**An Independent Review  
of the Report**

**PROPOSED SUBSURFACE INTERIM MEASURES/  
INTERIM REMEDIAL ACTION PLAN/  
ENVIRONMENTAL ASSESSMENT  
and  
DECISION DOCUMENT  
Operable Unit No. 2**

February 22, 1993

# Rocky Mountain Universities Consortium

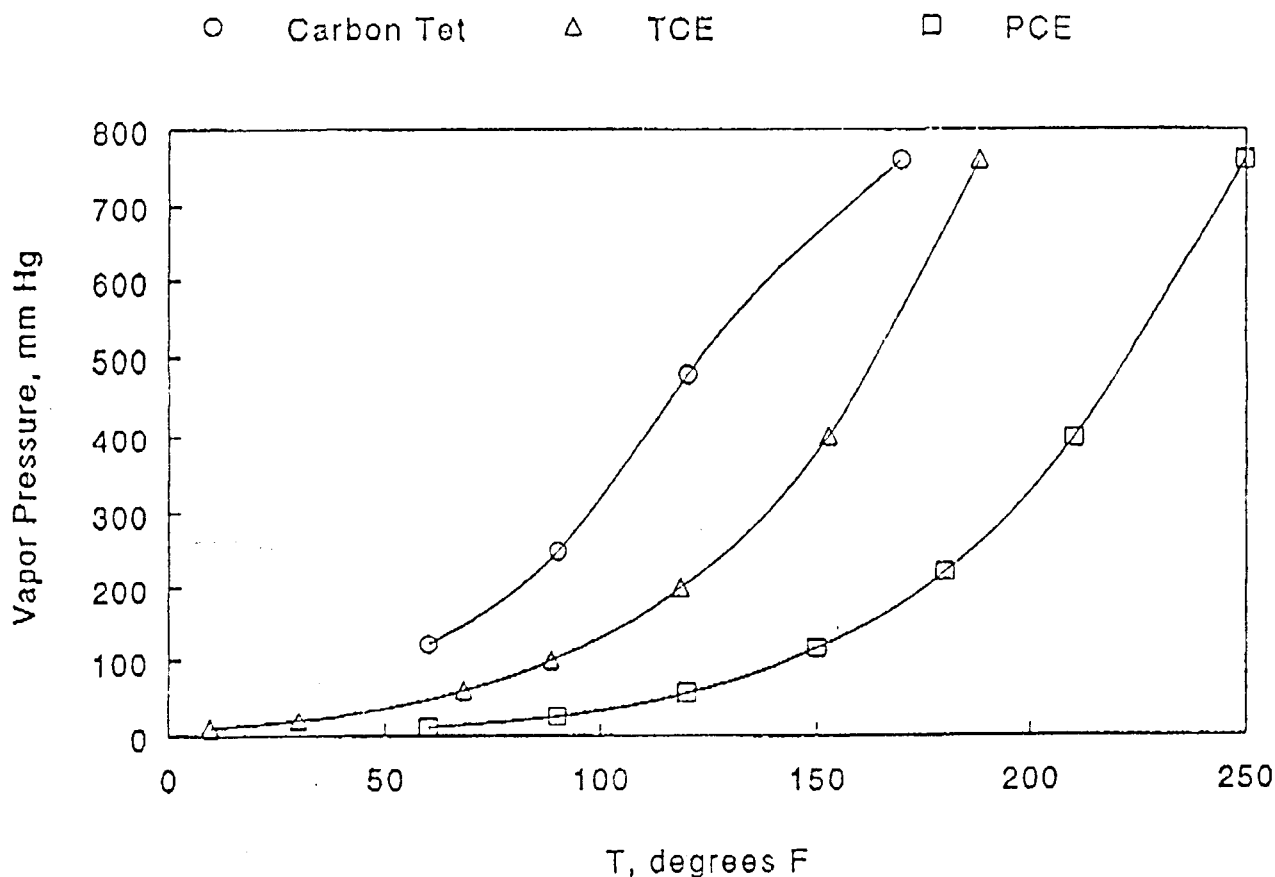
While all three target contaminants are classed as VOCs, they are quite different from each other, suggesting that they should be treated somewhat differently. The volatilities of the three compounds are reflected in the vapor pressure curves, shown in Figure 1. It should be noted that the gas-phase equilibrium content of any one of these compounds, in contact with its liquid phase, is directly, proportional to its vapor pressure. Thus, carbon tetrachloride ( $\text{CCl}_4$ ) is the most volatile of the three, followed by trichloroethylene (TCE) and tetrachloroethylene (PCE). This relationship suggests that  $\text{CCl}_4$  can be removed at lower temperatures than the other two target contaminants, progressing to PCE as the one which may require the highest stripping temperature.
